PRODUCT CHANGE NOTICE

**Product Improvement –Design
Change for the Listed Intersil
Products**

**Refer to:
PCN14062**

Date: December 19, 2014

PCN14062 – Appendix I

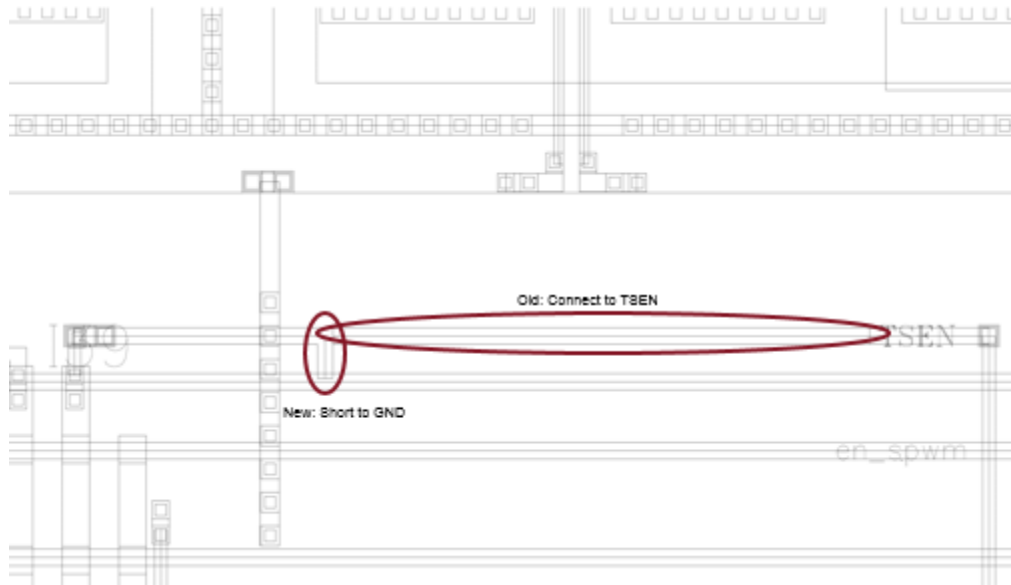
Schematic change, one cut / metal routing where a 3 input NOR Gate was changed from TSEN to GND, this re-routing requires one simple one layer metal edit. Design validation and simulation runs complete.
